**INQUIRY INTO IMPACT OF THE WESTERN HARBOUR
TUNNEL AND BEACHES LINK**

Organisation: 1st Northbridge Sea Scouts

RE: RMS BEACHES LINK (SSI-8862) – Submission in Objection

Figure 9 EIS chapter 6 – Key plan and construction footprint

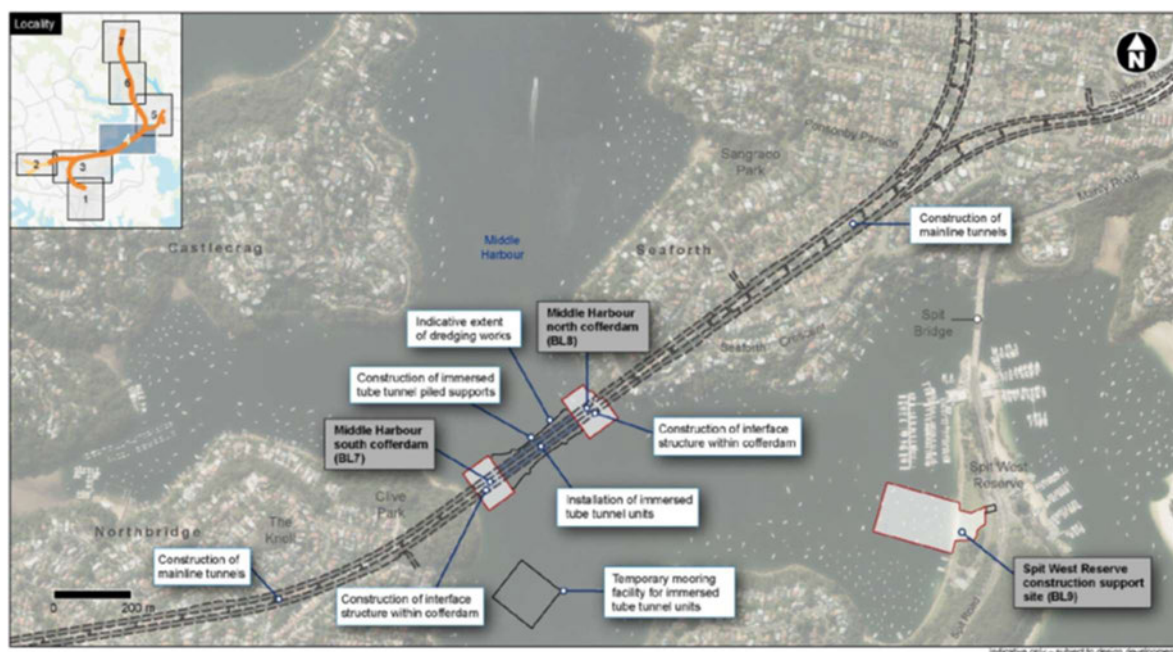
It can be seen from **Figure 9** and **Figure 10** that the location of the Proponents new harbour crossing, the construction zones, the restricted waterways, and the location of the temporary tunnel storage units and Spit West construction site, is in direct conflict with the Primary Boating Activity waterway area of Middle Harbour.

Figure 11 Harbour Crossing construction, overlaid with the 1st NB Boat Shed, J24 Mooring and Beauty Point canoe training area

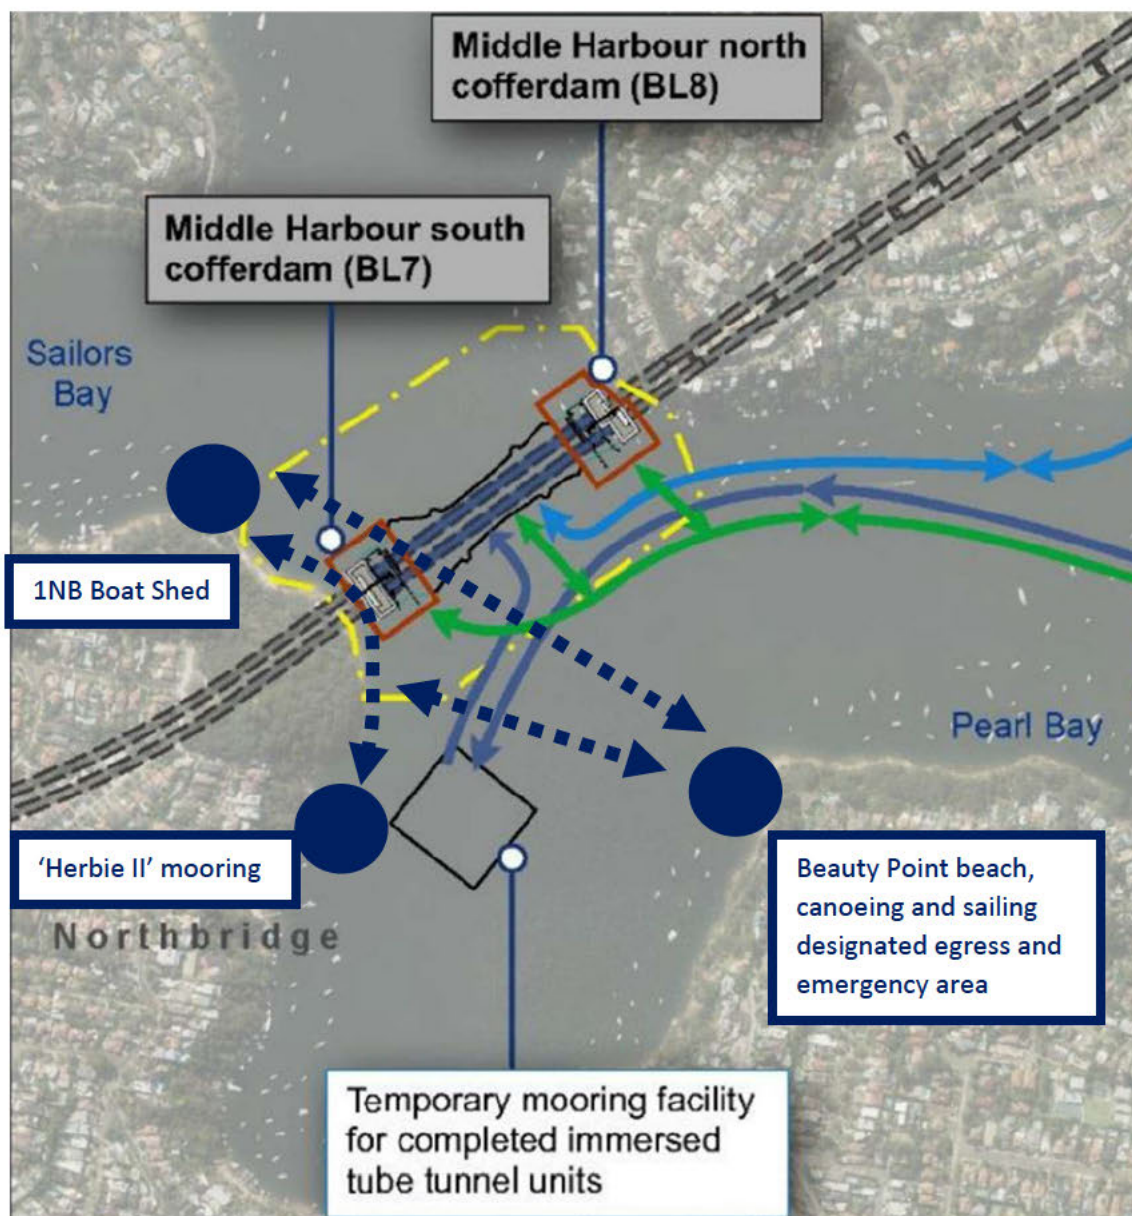
The tunnel construction and the location of the temporary tube mooring facility is in direct conflict with our current and preferred canoe training areas and our Primary Boating Activity areas, refer to Figure 11 below:

Further, our 'Herbie II' (a J24 keeler) and its swing mooring location, is now effectively isolated (refer to Figure 11) from our Boat Shed. This boat is used for sail training and as a secondary safety boat. Herbie II is 'typically' sailed north from its mooring between 17:30-18:30hrs (most summer weeknights) to the central Middle Harbour area and then west to our Boat Shed and it is then returned to the swing mooring between 19:30 and 20:30hrs.

Our Scout Group Committee and Scout Leadership request that the Proponent relocate our J24 keeler to a new mooring (located within 200m of our Boat Shed) for the duration (or permanently) of the primary maritime works and for at least until 12 months post Substantial Completion of the works (to allow for works maintenance). If an existing mooring is not available, we request that the Proponent establish a new mooring and/or a piled-fixed/tandem mooring (at their cost) for the full duration of the pre-construction and primary maritime works.

Figure 12 EIS Appendix F – Traffic and Transport (Part 2) – Draft Construction Management Plan (with unconfirmed restrictions)

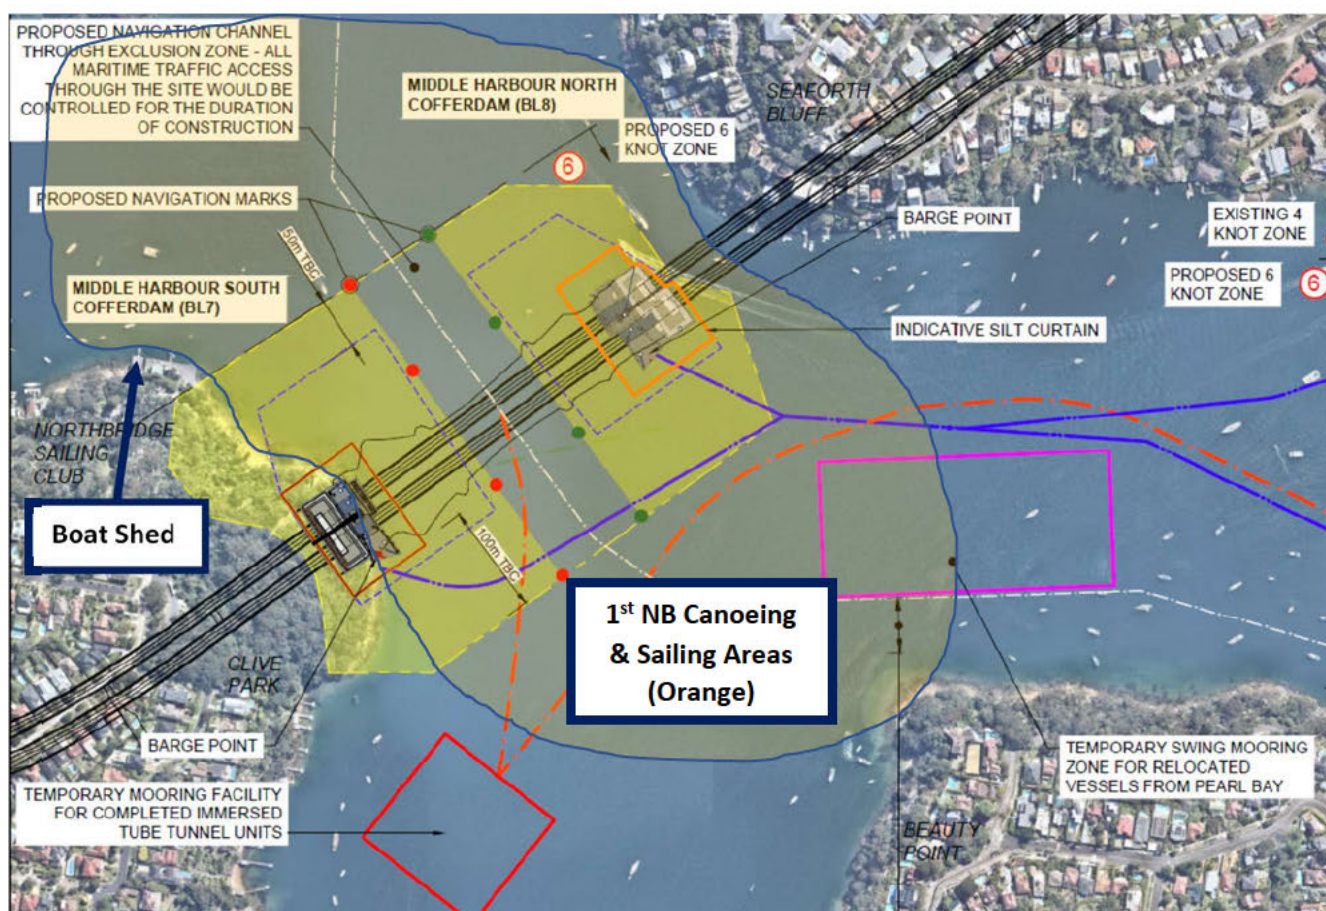
The proposed waterway restriction area (refer to Figure 12) poses significant risks and hazards to our normal Primary Boating Activity waterway operational area. The planning and location of the navigation markers, immersed tubes and coffer dam works have not been made in discussion with the local maritime users, the navigational impingements are not safe for canoeing and/or sailing vessels (i.e. non-powered vessels).

Note: Another EIS documentation “error”, the maritime construction site and coffer dam work area (BL7) are now shown within the Clive Park Heritage Area and overlay with the Aboriginal caves/shelter and artwork site locations.

Figure 13 EIS Chapter 17 and Appendix P - Hydrodynamic and dredge plume modelling (the 98th percentile would the wider fetching)

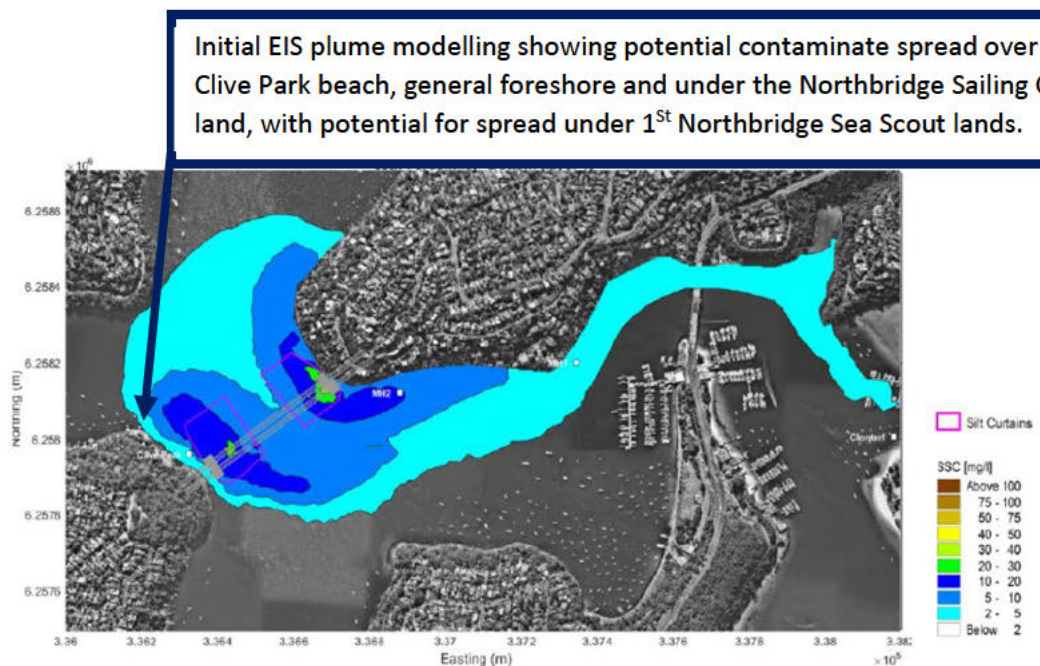
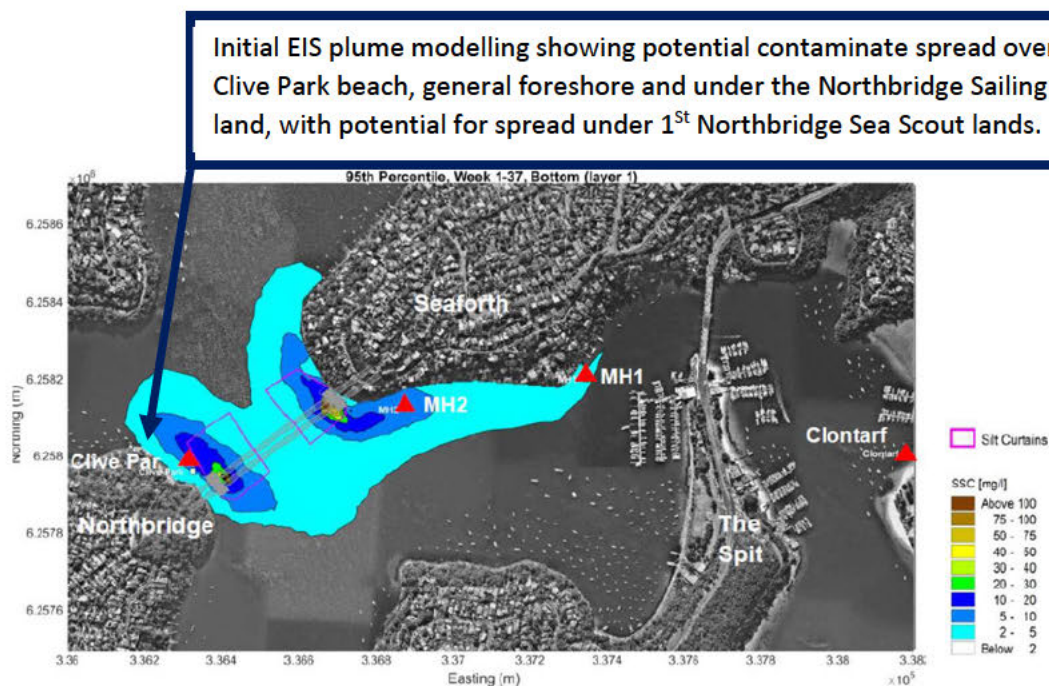
that a 98th percentile drift and sedimentation profile is adopted for human health risk assessment purposes, and that human health effects are tested as a primary outcome of the revised modelling.

Figure 16 App G Noise and Vibration – BL7 (Standard Hours), LAeq (15min) at 70-75dB(A) at the Northbridge Sailing and Boat Shed (Green)

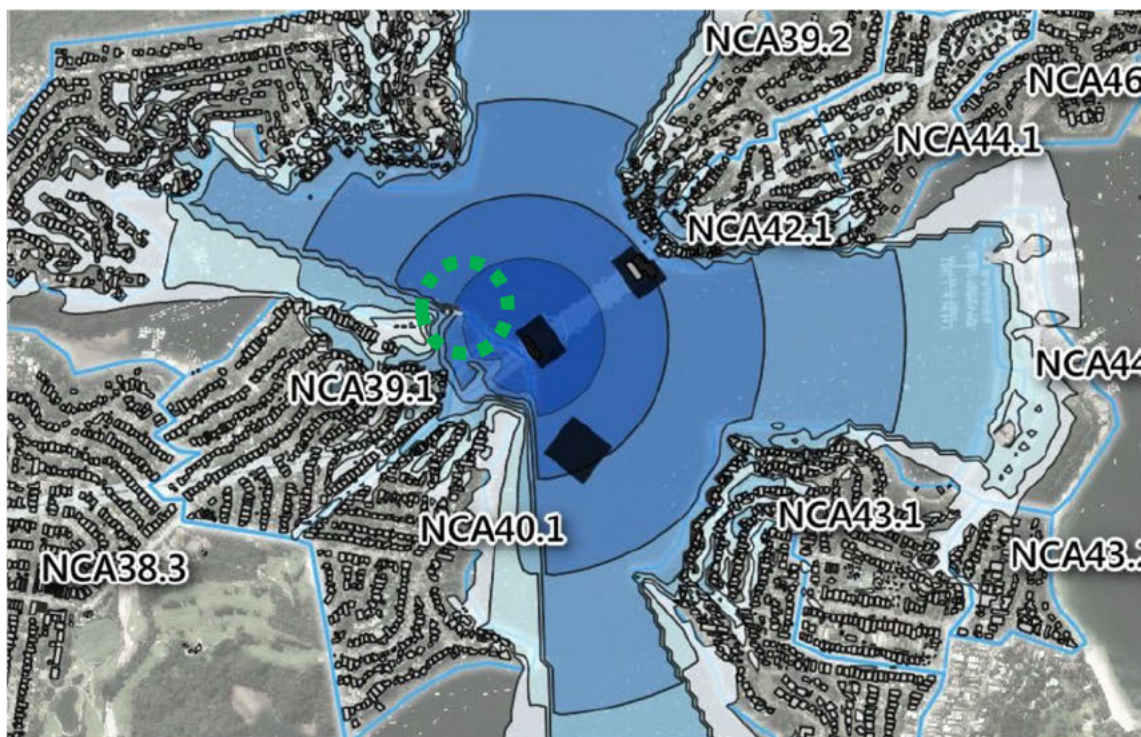
We dispute this positions, both the Northbridge Sailing Club rooms and 1st Northbridge Boat Shed (along with numerous residents in Northbridge and Seaforth) will be subjected to prolonged periods of construction noise between 70-75dB(A) as shown in Figure 16, extracted from the EIS.

This level of noise exposure is considered by the NSW Environmental Protection Authority (NSW EPA), as a **'Highly Noisy'** environment (refer to Figure 17) and in our opinion, prolonged periods of exposure to this high level of construction noise can and will be damaging⁷ to our young Scouts, to our canoeing and sailing groups, and to the local residential and to the public using Clive Park Heritage Area.

Figure 20 Beaches Link interactive portal overlaid with the Clive Park shelter/cave location (blue shaded and dashed line)

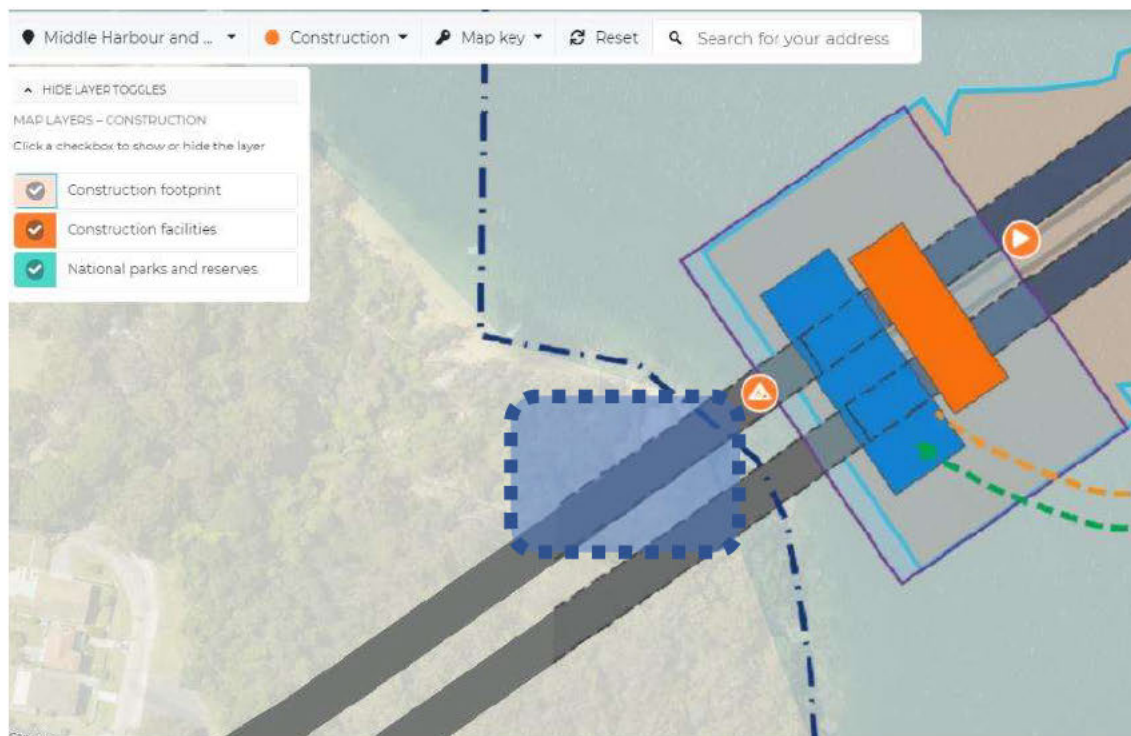
The north bound tunnel and associated rock bolting used with this type of construction, and based on the EIS tunnel and coffer dam sections/sketches (which are not detailed nor definitive), the rock bolts will probably be located within 10-15 metres and the tunnel crown at 15-20 metres to the bottom of the rock outcrop.

There is therefore high potential of Aboriginal shelter/cave site subsidence, high potential for significant damage to irreplaceable Aboriginal caves/shelters and to listed artworks, or in the **worst case full rock face collapse** and the risk/hazard to our young Scouts and to the public, who frequent this park area, due to the Proponents tunnelling and adjacent coffer dam works (refer to **Figure 20 and Figure 21**).
